**REPORT OF THE JOINT COMMITTEE APPOINTED BY HON'BLE NGT (SZ) IN O.A NO. 225 OF 2021, AS PER ORDER DATED 22/11/2021, REGARDING LARGE SCALE CONSTRUCTION GOING ON IN THE CRZ AREA WITHOUT OBTAINING NECESSARY PERMISSIONS IN KARWAR BEACH AND KALI RIVER BANK IN THE STATE OF KARNATAKA KARWAR TALUK, UTTARA KANNADA DISTRICT -REG.**

Site locations super-imposed on existing approved CZMP as CRZ Notification 2011

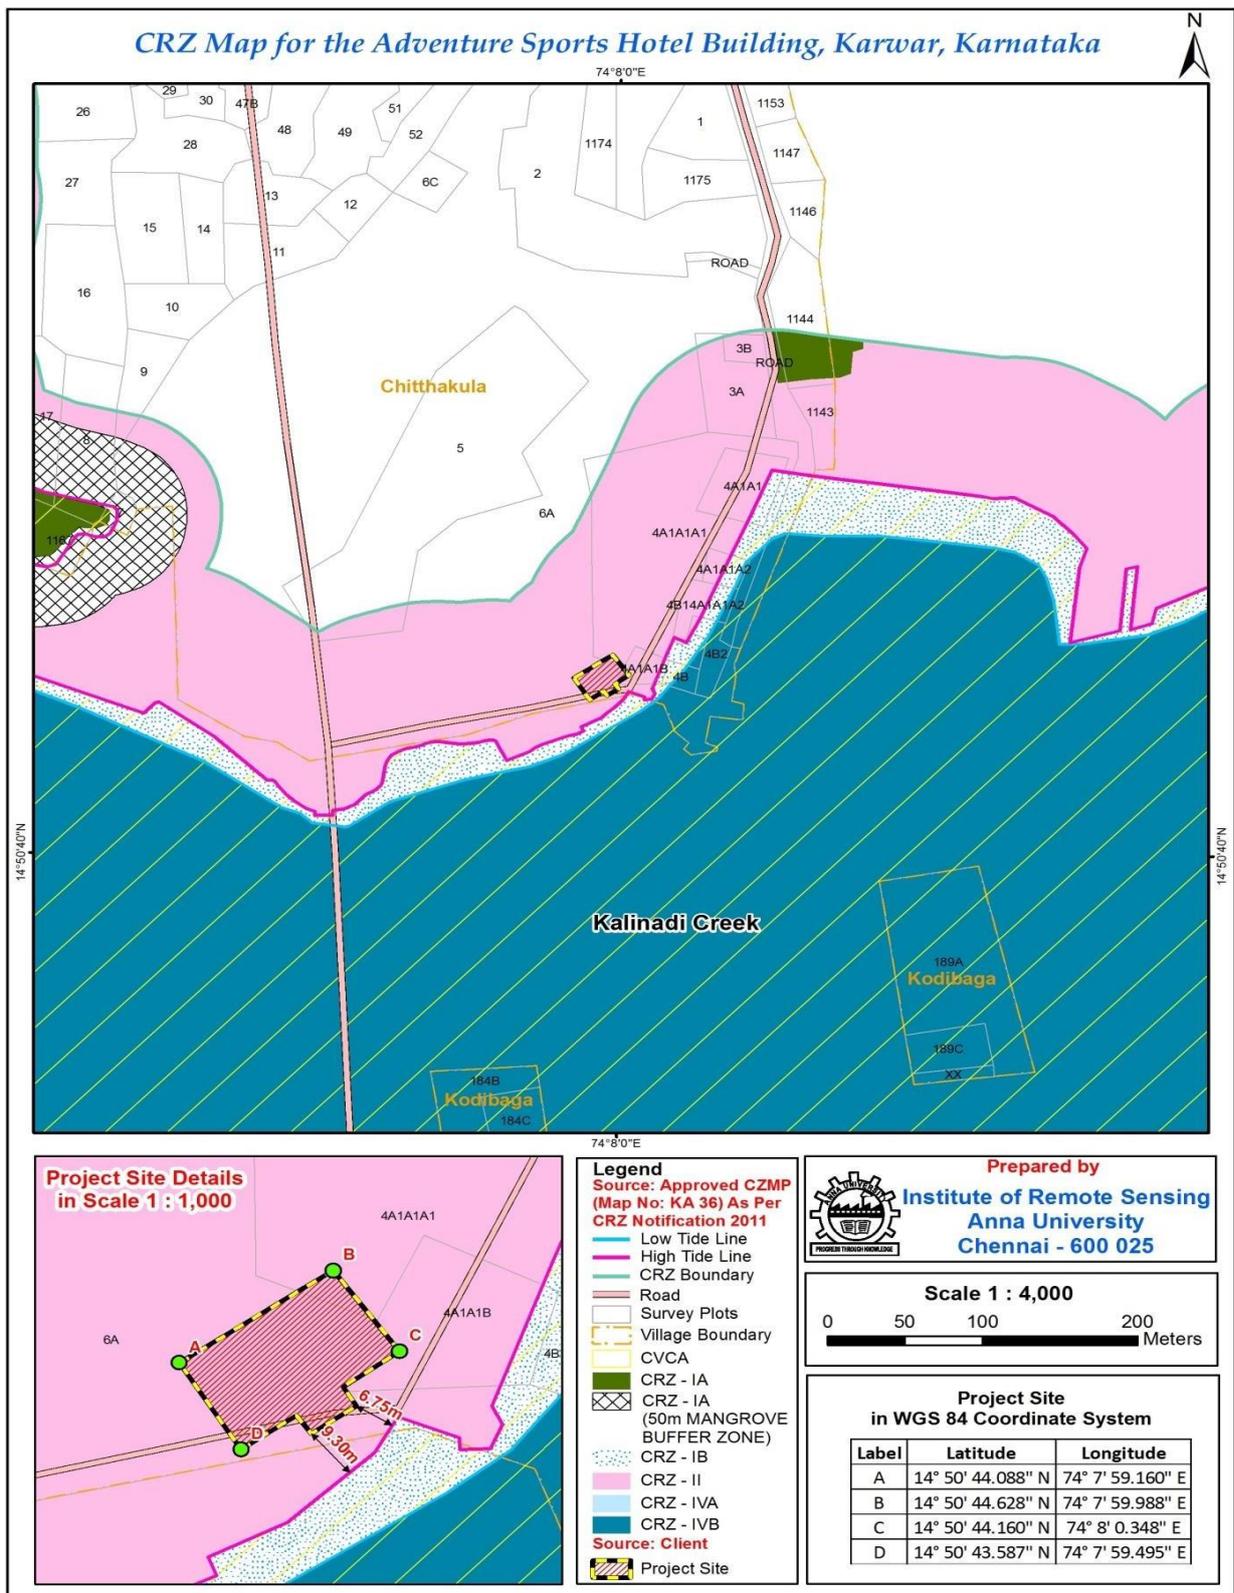
From the above map it is clear that the Adventure Sports Hostel building is in CRZ-II, which indicates the violation of CRZ Notification.

# CRZ Map for the Kali River Garden, Karwar, Karnataka

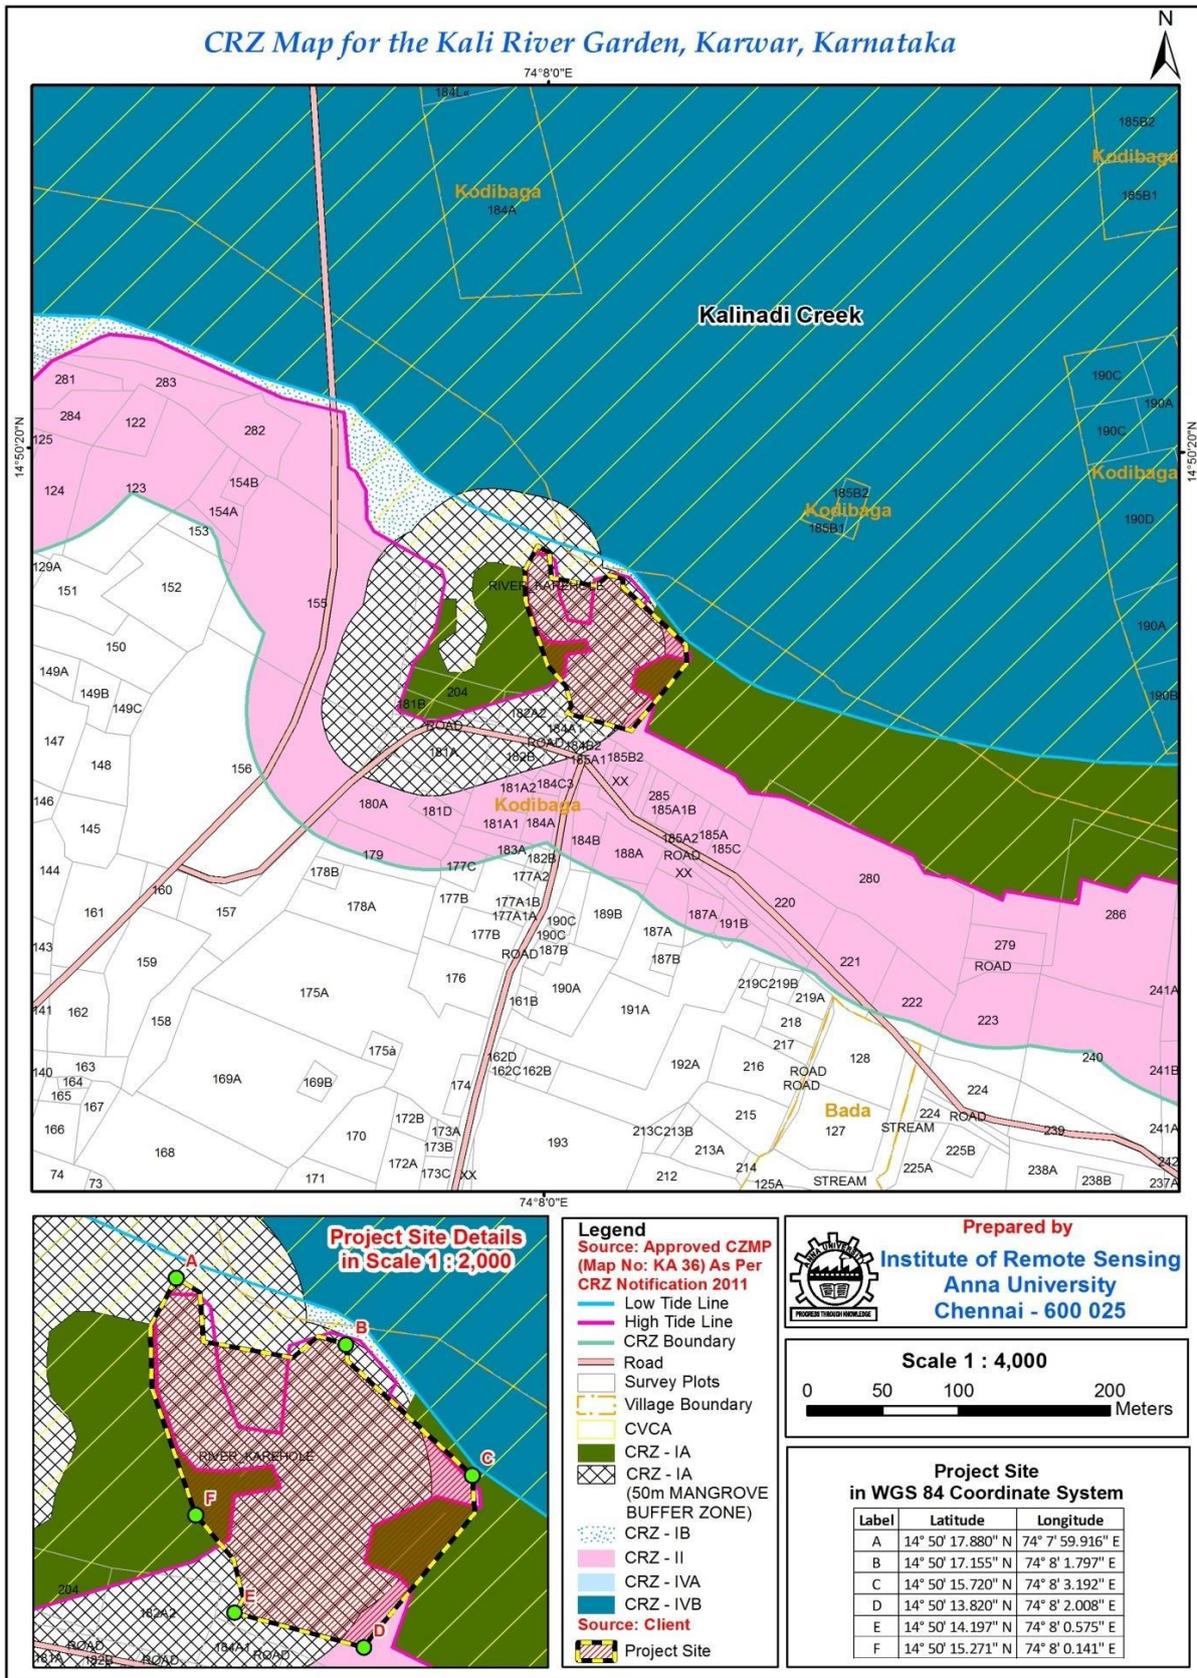
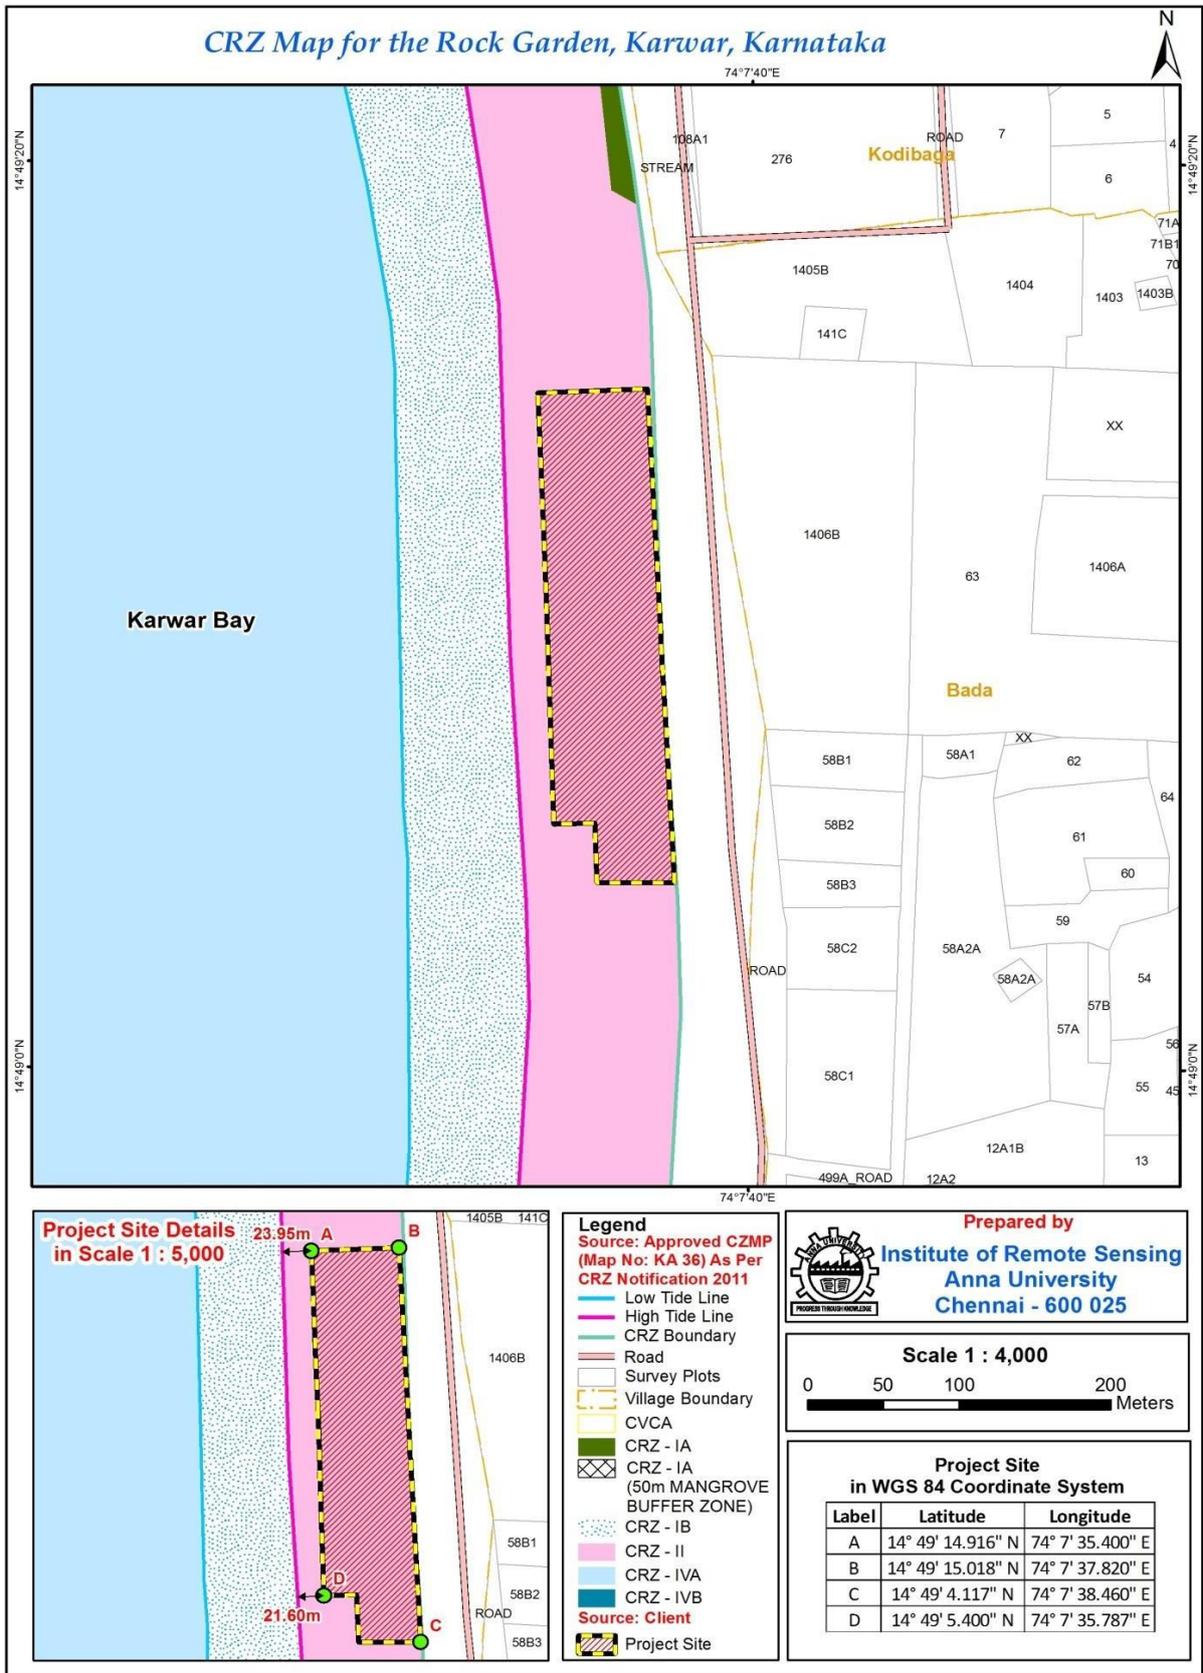
From the above map it is clear that the Kali River Garden area is in CRZ-IA, IB & II Zone, however it is developed on the existing jetty, with KSCZMA approval

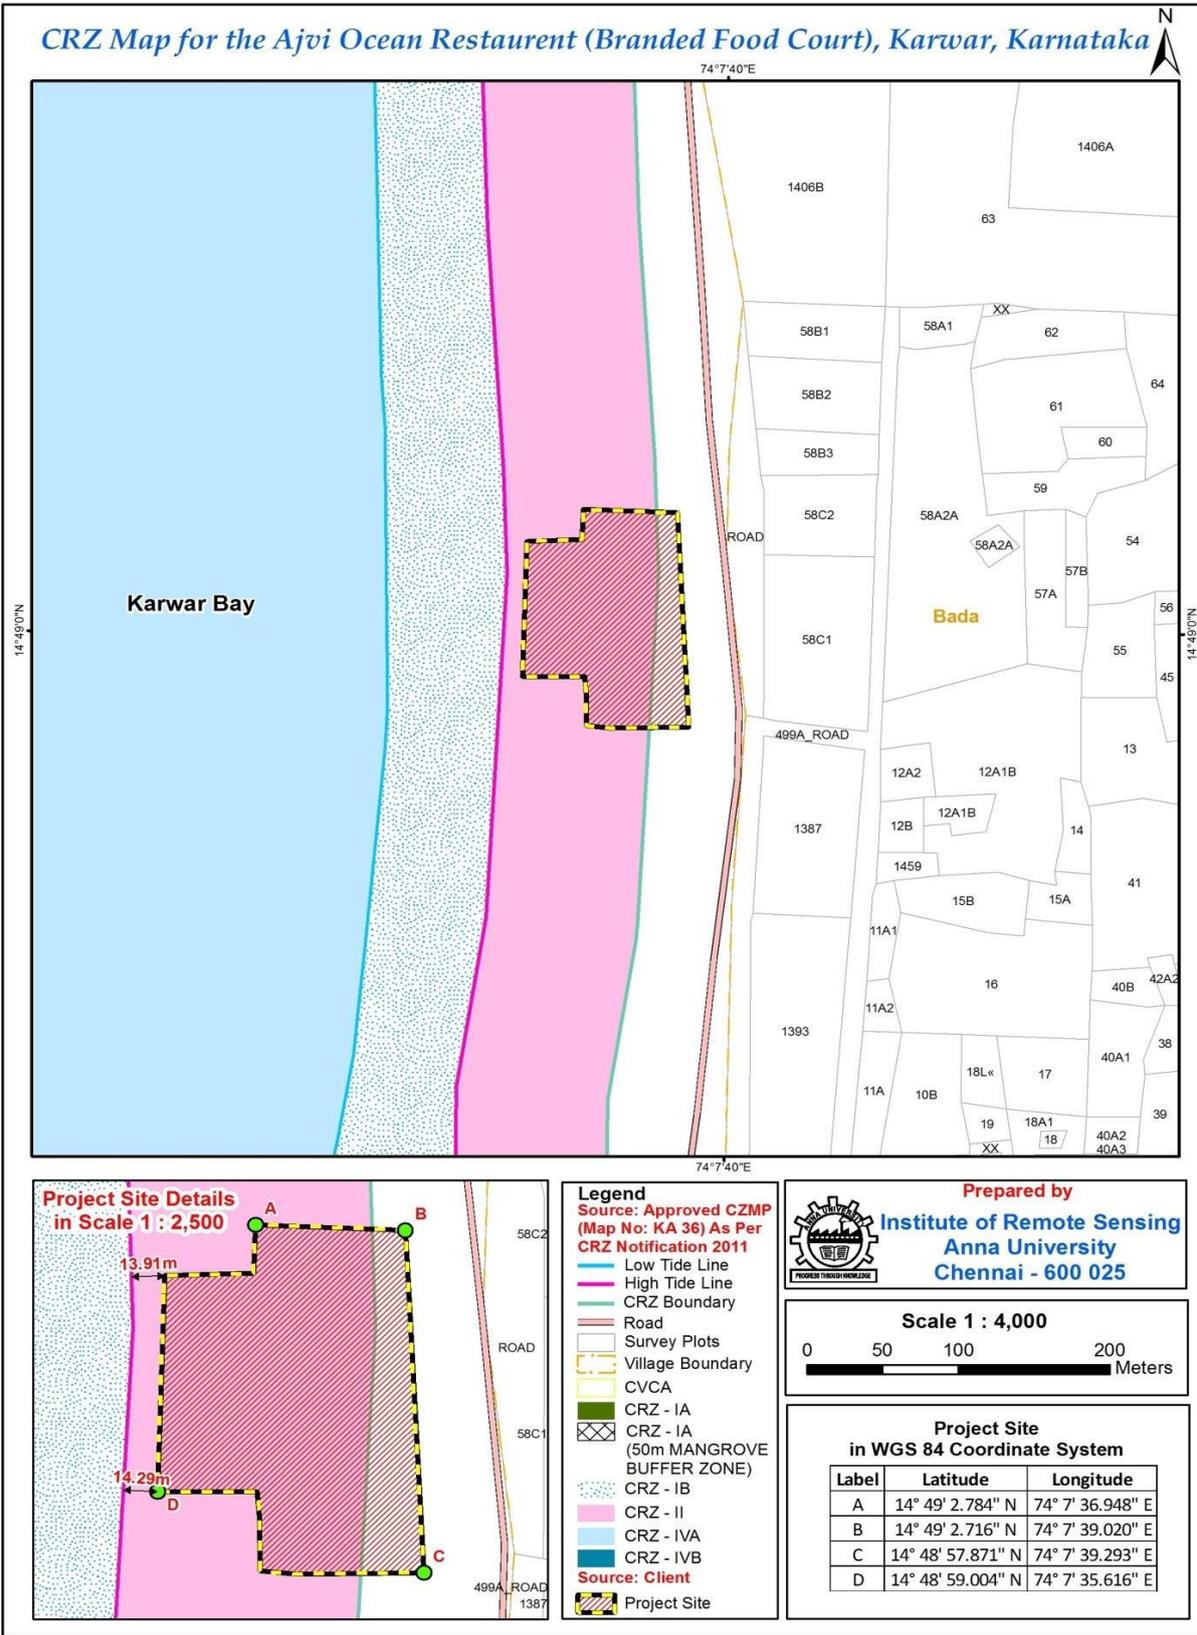
From the above map Rock Garden is constructed in CRZ-II zone, which indicates clear violation of CRZ Notification 2011

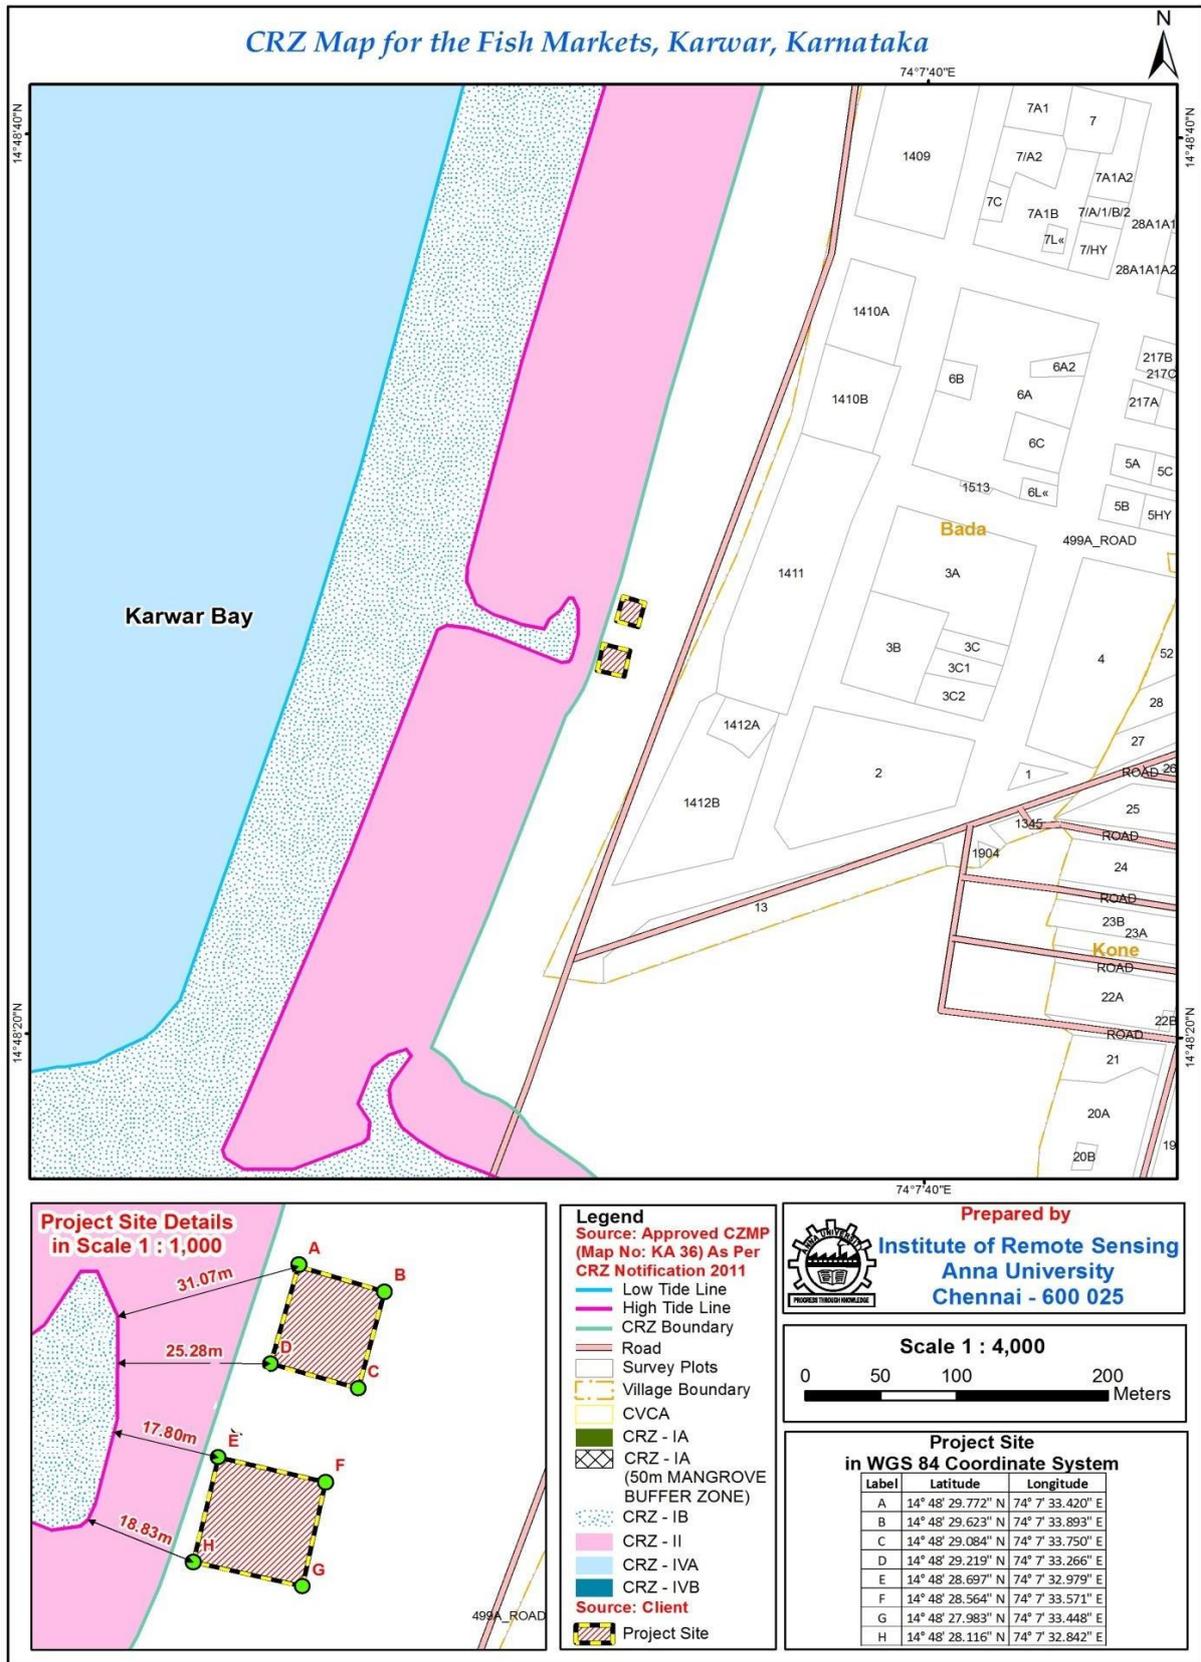
From the above map Drive-Inn Hotel & Nelasiri building is constructed in CRZ-II zone, which indicates clear violation of CRZ Notification 2011
